# *Liverpool Growth Centre Precincts*

*Amending Development Control Plan  
(Austral ILP Amendment)*

*(Pre-Gateway) May 2019*

Note this draft DCP omits text which are not intended to be amended. Several sections objectives and controls have not been reproduced in this document, only sections of relevance have been displayed. Text which is to be inserted is shown in green and underlined, text which is to be deleted is shown in ~~red with strikethrough~~, explanatory notes, which will not form part of the DCP, are shown in *blue italics*.

**Figure 3-49 3-25:** Temporary half road width construction

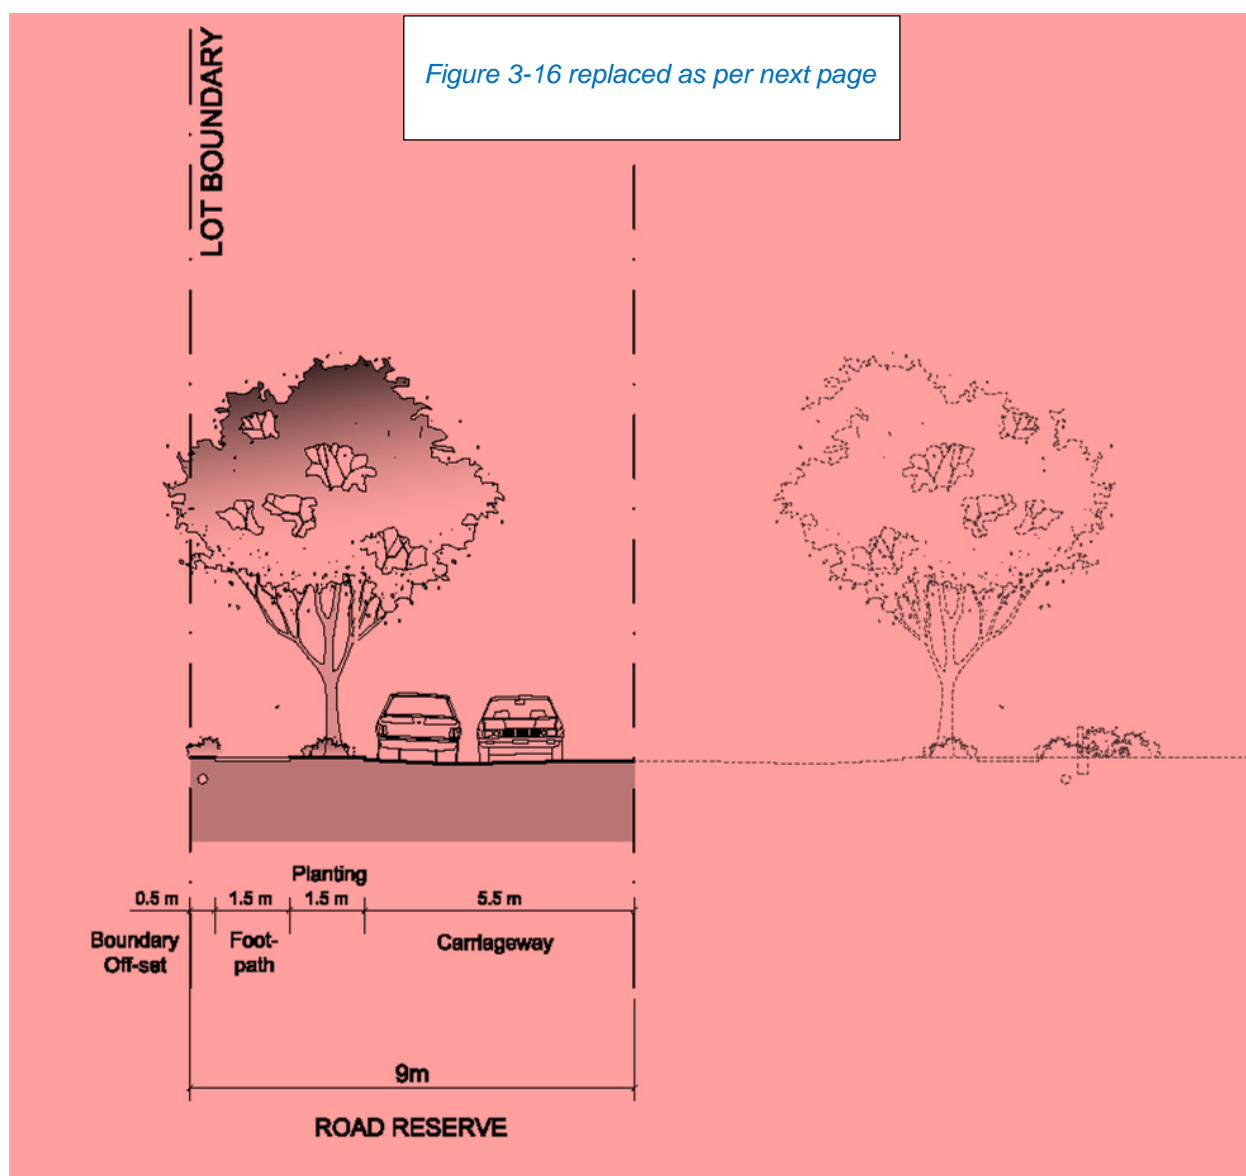
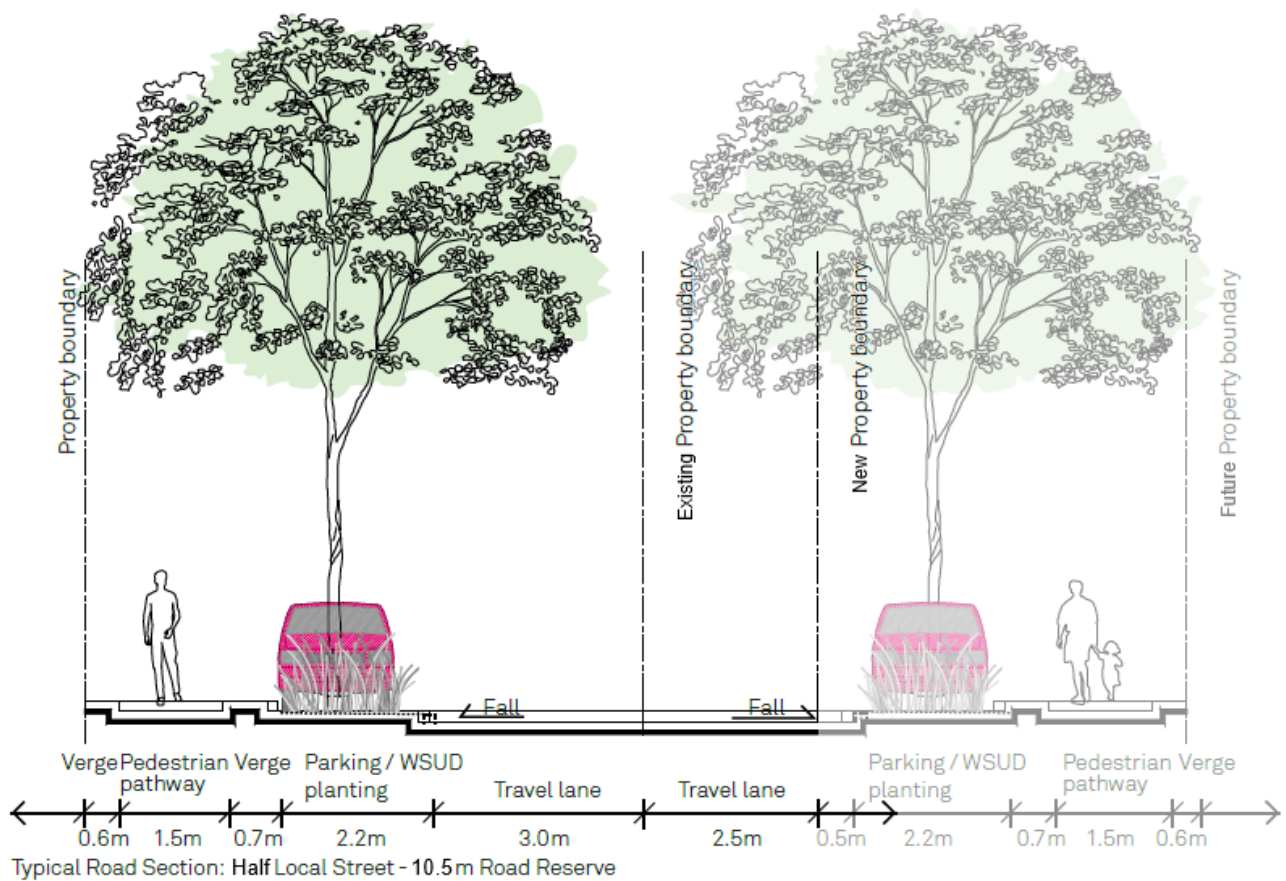
- ~~6- 11.~~ In all other circumstances a Half-width local roads must be constructed to provide temporary access to residential development, in accordance with **Figure 3-19** **Figure 3.25**. Due to the need for significant adjacent property widening, this is now the last-resort solution, in which roads must be constructed in this manner if not utilising any of the methods above. The applicant will cover all costs associated with the design of the full road width and construction of half the full width pavement, including temporary and permanent drainage infrastructure, adequate transitions to full width cross sections, plus a two way traffic configuration ensuring operational effectiveness and safety to relevant standards. This text has been moved to control 6. The 2.5m of additional widening on the adjacent property(ies) will require adjoining owner(s) consent. Council will generally not

consider moving the road centreline. Consent is required for any land in which development is being carried out, including land which only includes the construction of roads. Moving the centreline will have knock on effects on other properties and could lead to a more disconnected road network.

**Figure 6-2:** Typical industrial street

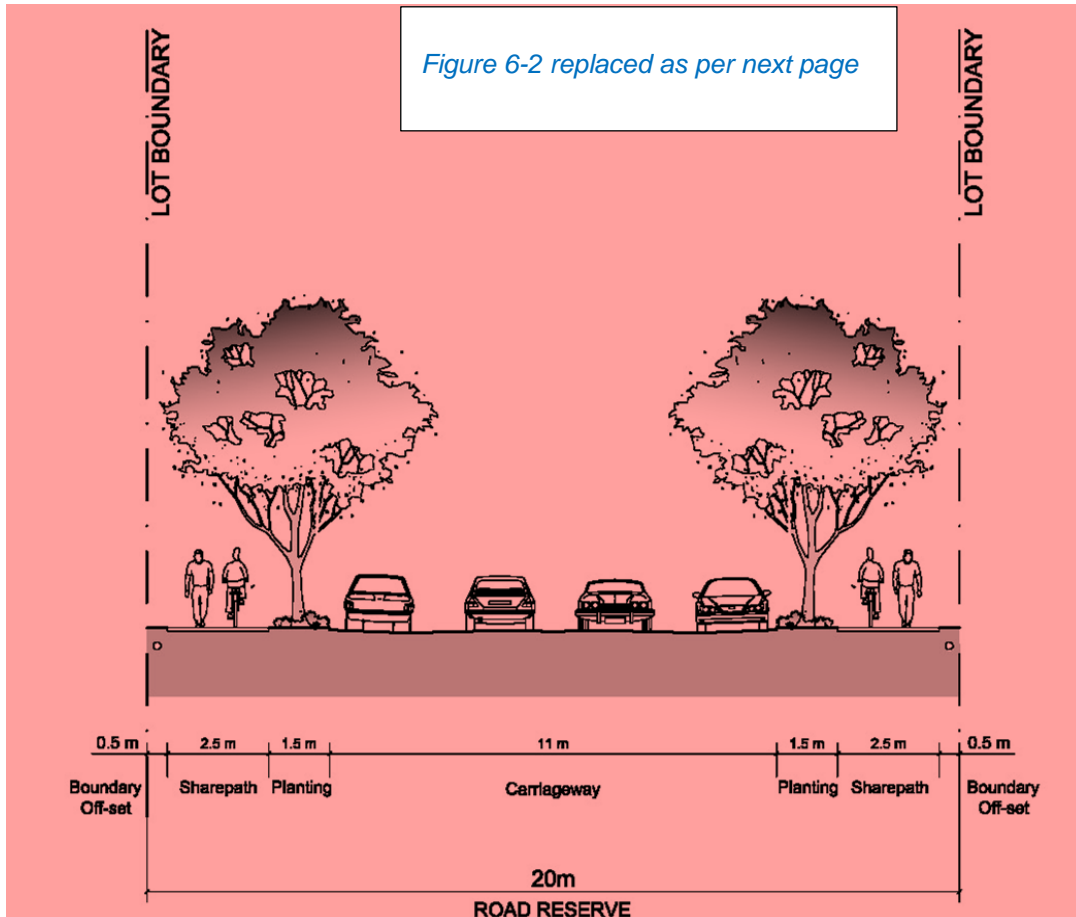
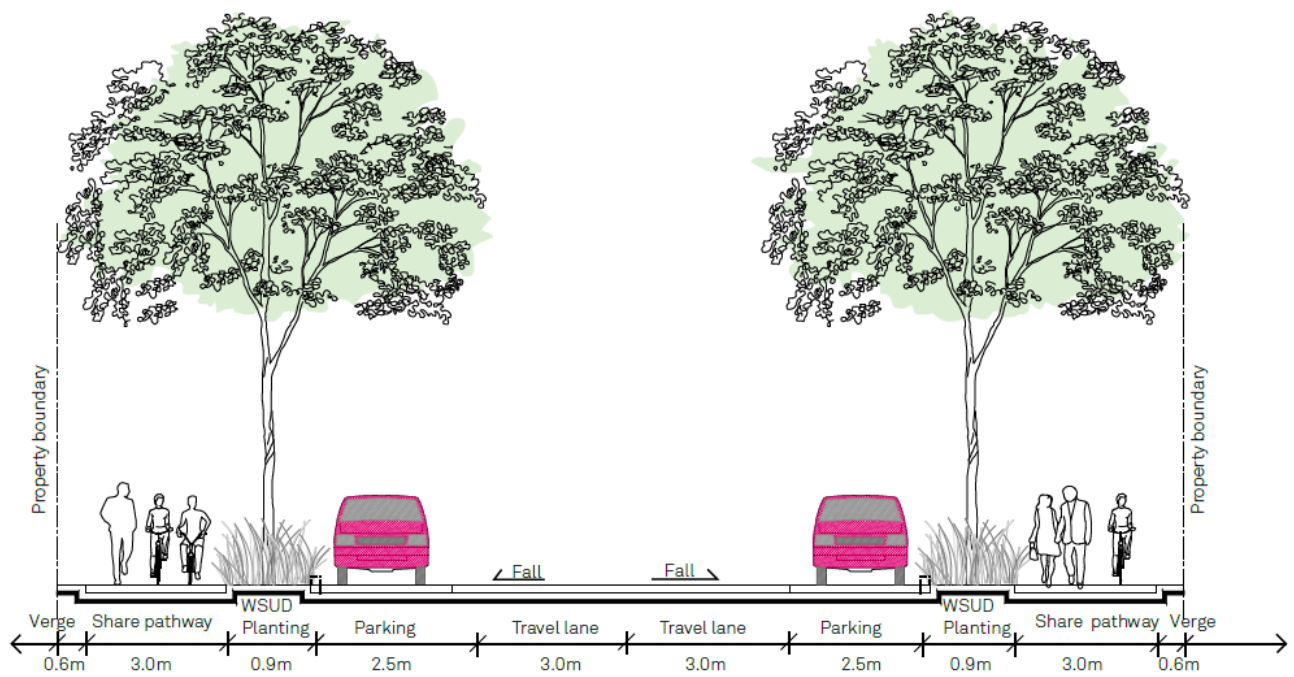
7. Half width Industrial Streets are to be provided as half of the typical section of **Figure 6-2**. A half industrial road contains 5.5m of carriageway, which is sufficient for two-way movement, but will likely require localised widening or complex manoeuvres for large vehicles entering/exiting sites.

1. Streets in industrial zones are to be designed and constructed in accordance with the typical cross section at **Figure 6-2**.
2. – 5. No change.
